Landmark Commission

**June 6th, 2019
1ST FLOOR CONFERENCE ROOM
4:30 P.M.
AGENDA**

APPLICATION FOR COMPREHENSIVE EXTERIOR RENOVATIONS TO 125 & 131 E WATER STREET

BIEMILLER - WEEDON BUILDINGS
ELEVATOR, STAIR AND STRUCTURAL PACKAGE
125 - 131 EAST WATER STREET
SANDUSKY, OH 44870

ELEVATIONS &
BUILDING SECTIONS

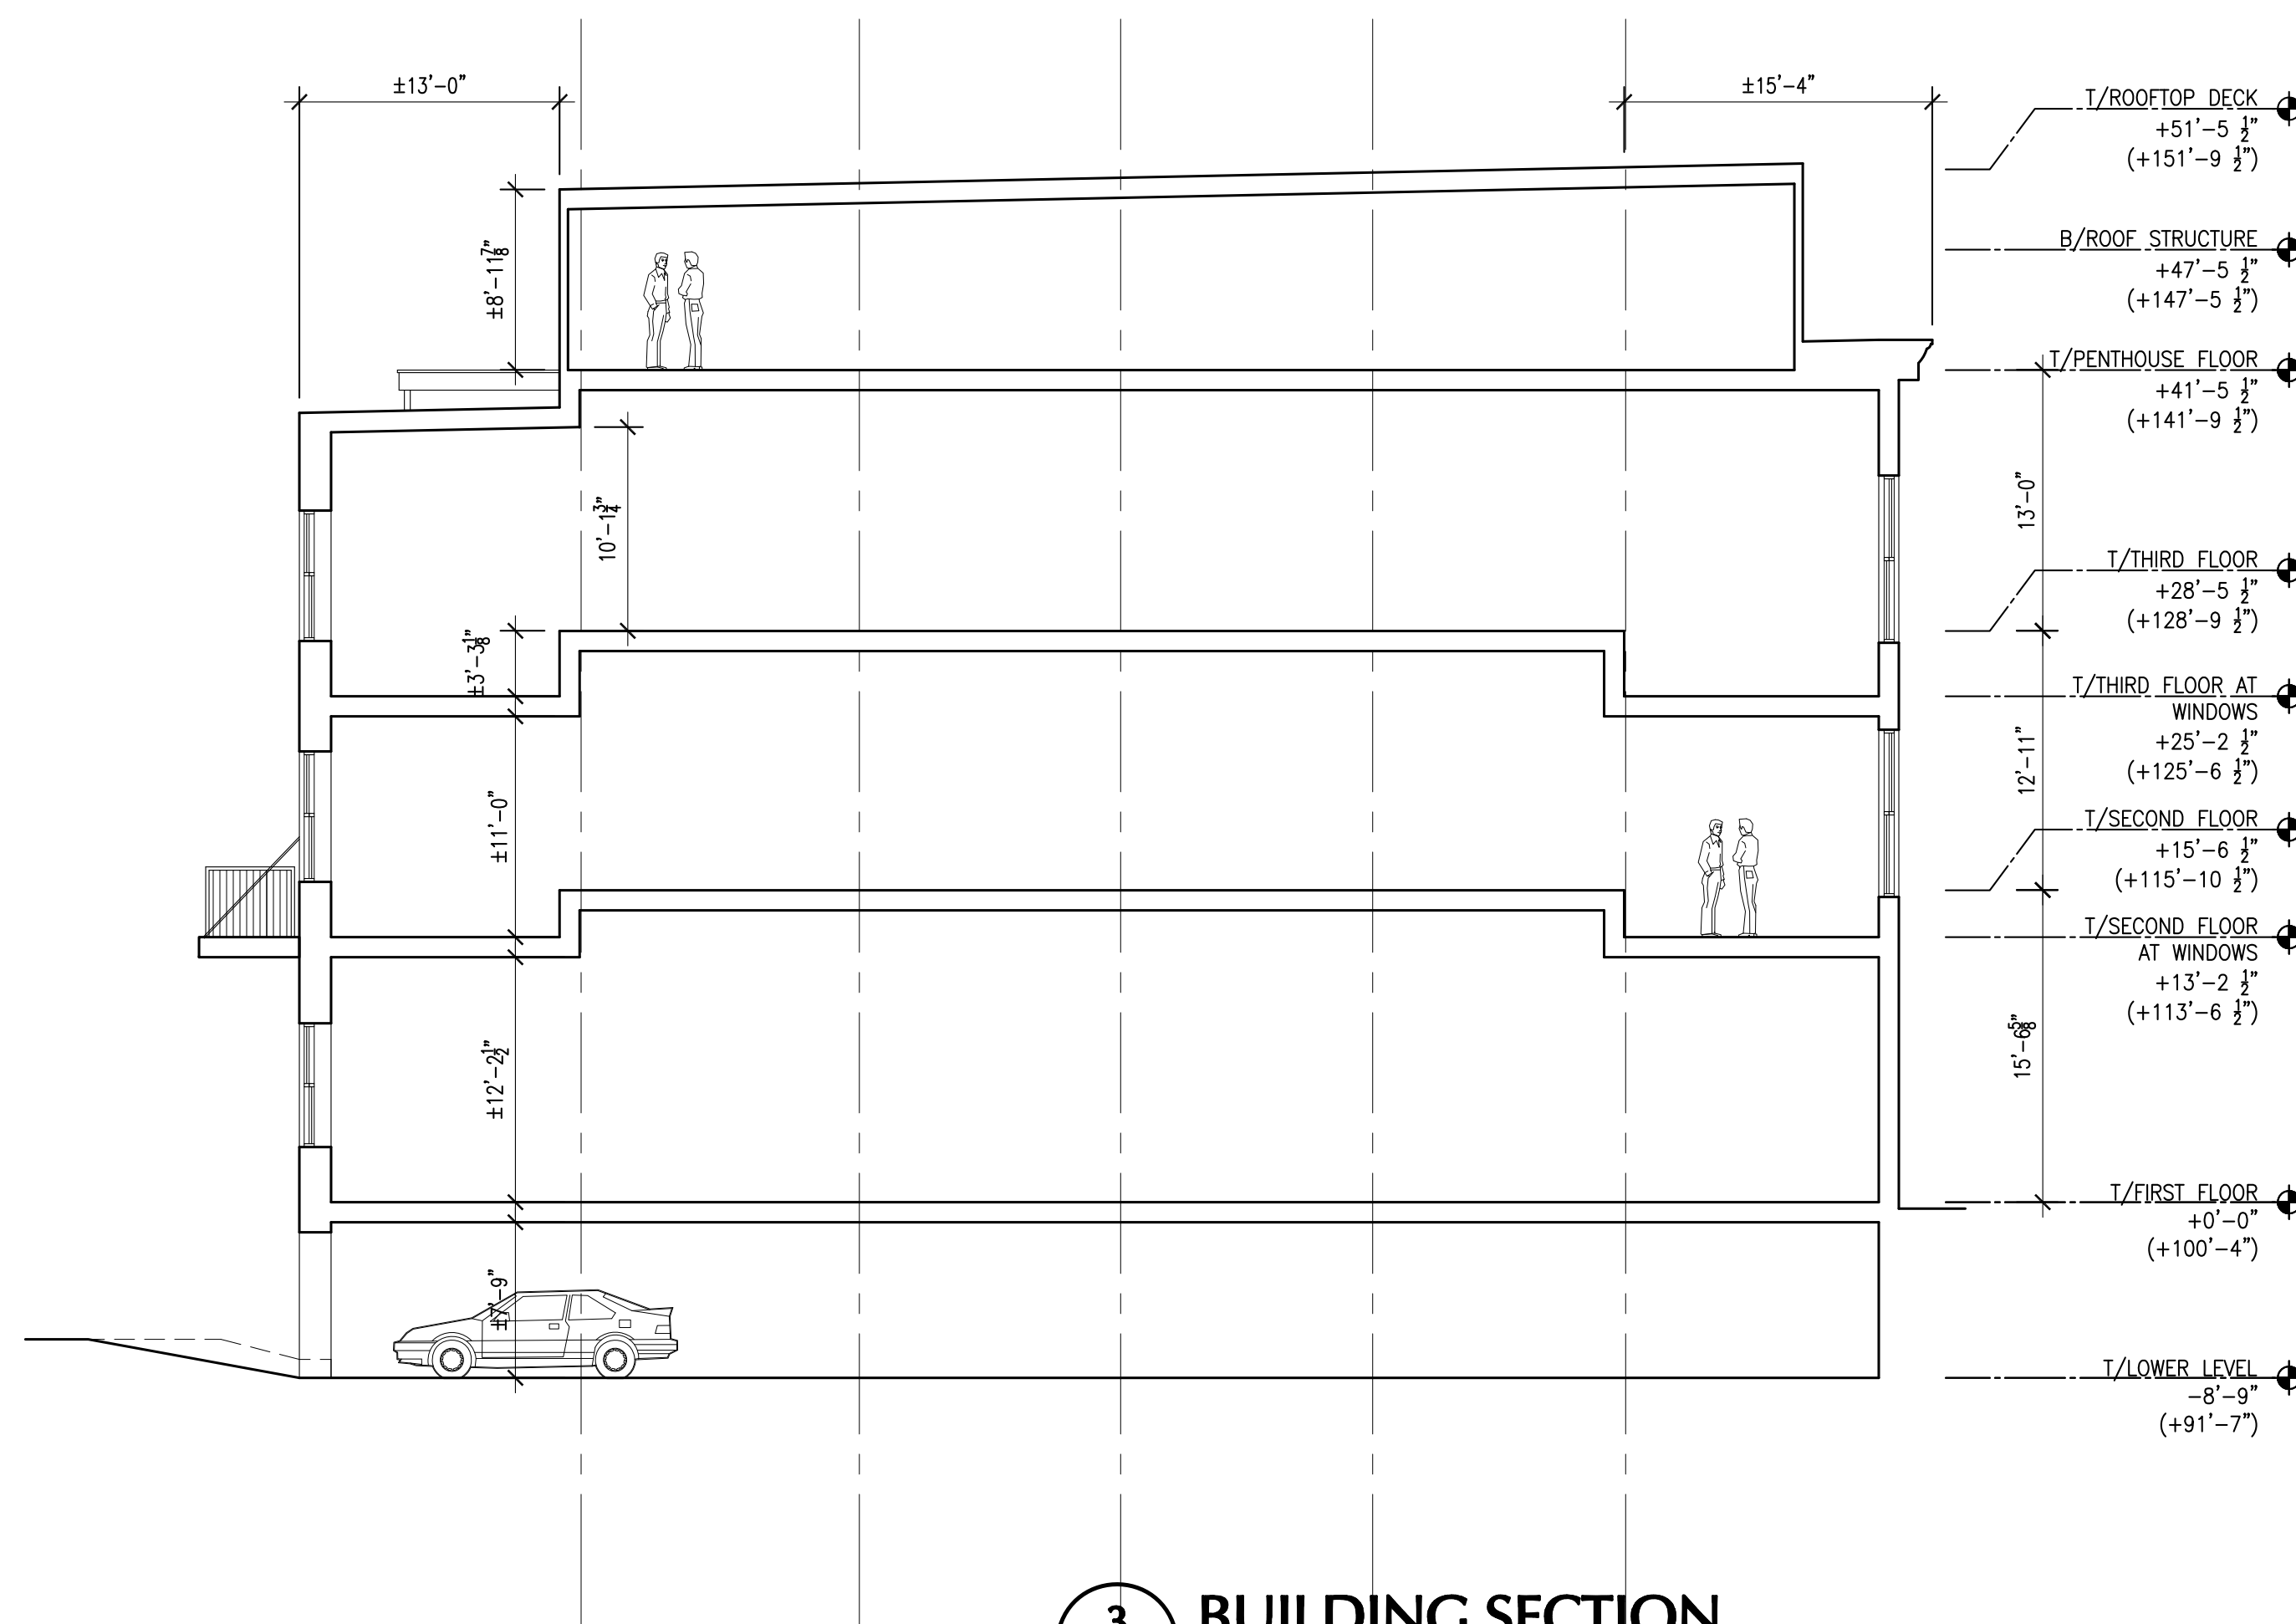
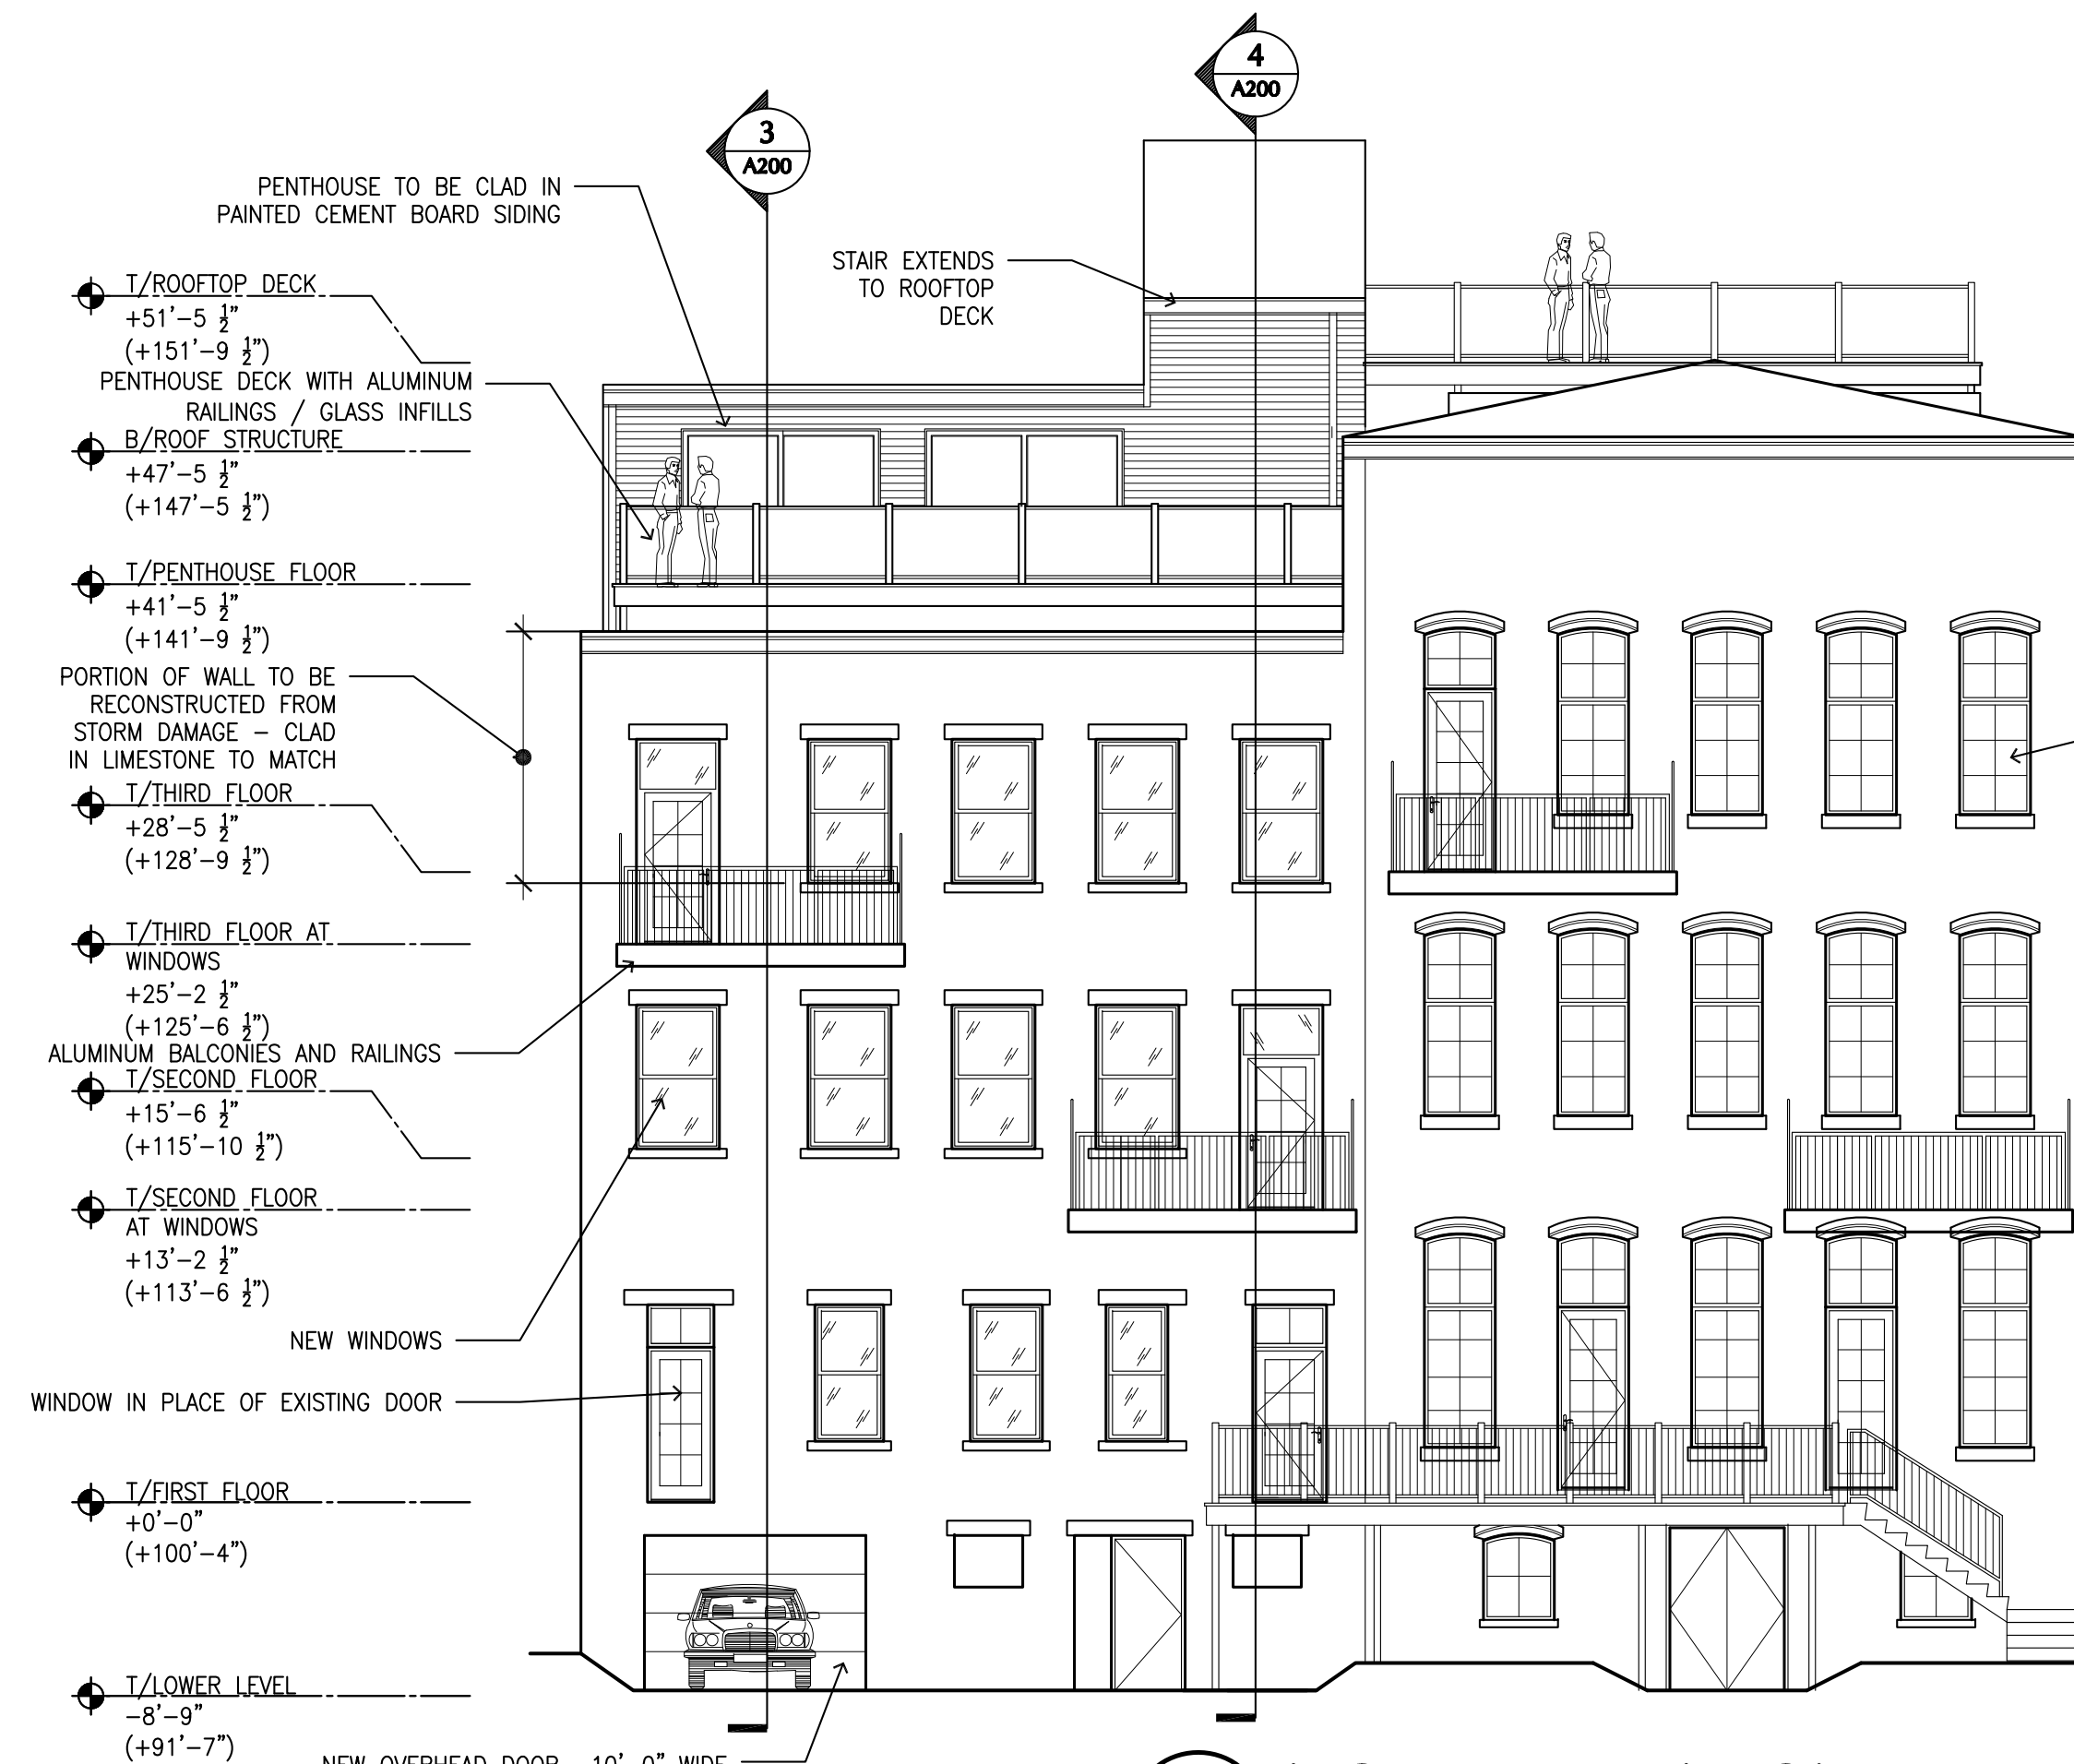
Staff recommends approval of all items for the Certificate of Appropriateness with the exception of the two garage doors on the north side of the 131 East Water Building. Staff's recommendation remains the same as it was for the LC-04-19 application.
